The Corporation of the District of Peachland

RE: New Monaco – Water Master Plan Update REV 2
Your File #: 12-623

As requested, the District and our consultants have undertaken a review of the recent submission by Aplin & Martin to the District of Peachland for a Water Master Plan Update REV 2 dated December 20th, 2012. The letter is signed by Matthew J. Temple, E.I.T. The intent of this submission is to provide the strategy for servicing New Monaco in the short and long term with water and inform the water servicing requirements for the development of a phased development agreement (PDA) between New Monaco and the District of Peachland.

Figure 1 – 20 Year Growth Demands

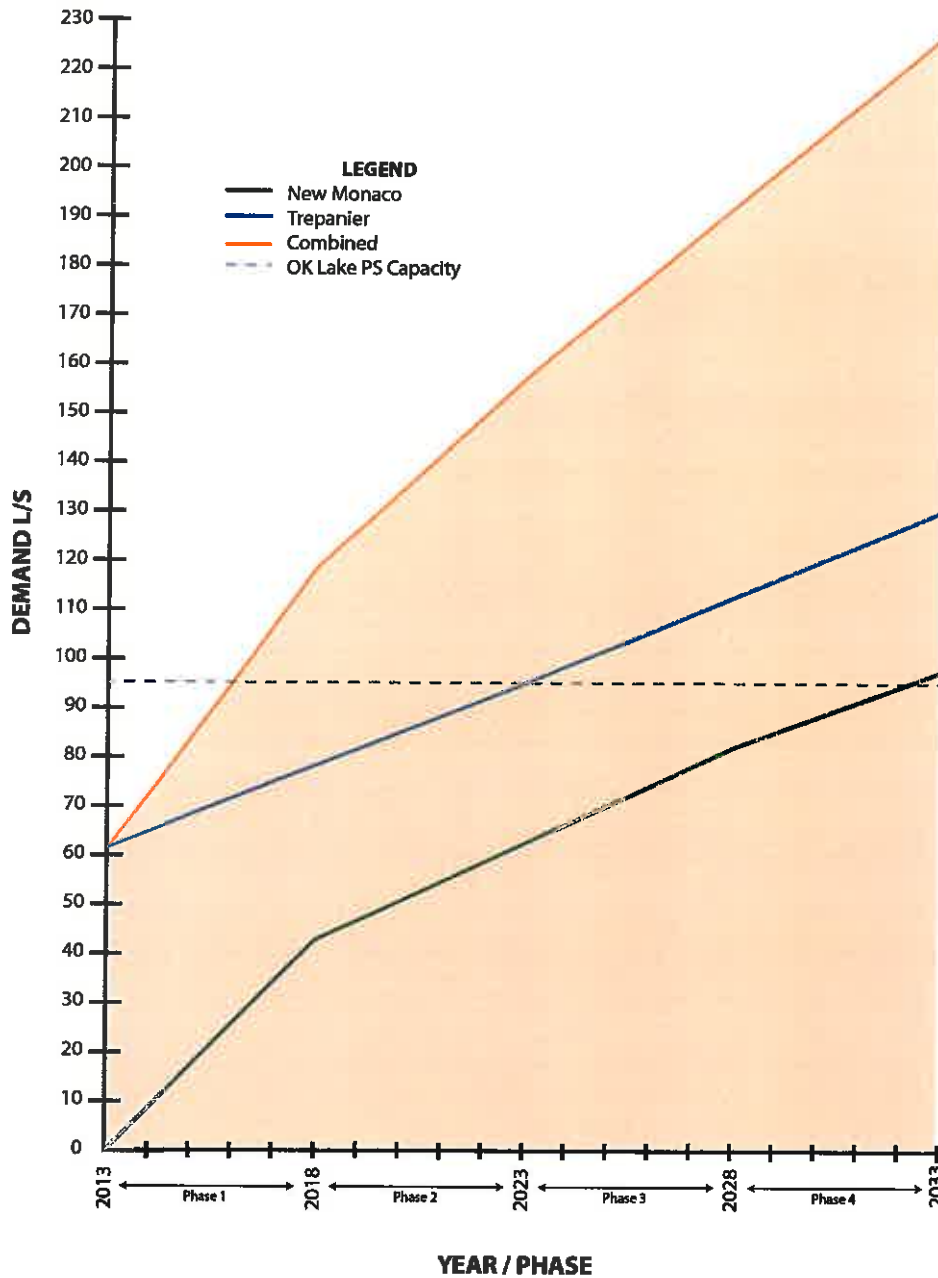
The MDD required for Phase 1 and Phase 2 is 63.6 L/s. The existing MDD in the Trepanier system is 61.2 L/s, resulting in a total MDD of 124.8 L/s. It is our understanding that the existing Okanagan Lake pump station can supply approximately 95 L/s with one duty pump operating. The second duty pump is used for standby. With an existing MDD of 61.2 L/s, the "spare" capacity is approximately 34 L/s. This amount of capacity could support the New Monaco development into the first 3 years of Phase 1. **Figure 1** below shows the growth in demands over a 20-year period.

Based on the above, the developer should outline in the final submission what the total short term MDD is (including New Monaco and the Trepanier Bench) and compare those against the capacity of the existing OK Lake booster pumps to ensure that:

- a) The pumps have the flow capacity to push to the existing reservoir site; and
- b) The pumps can reach the revised Cousins Road reservoir location at the total interim MDD flow rate.
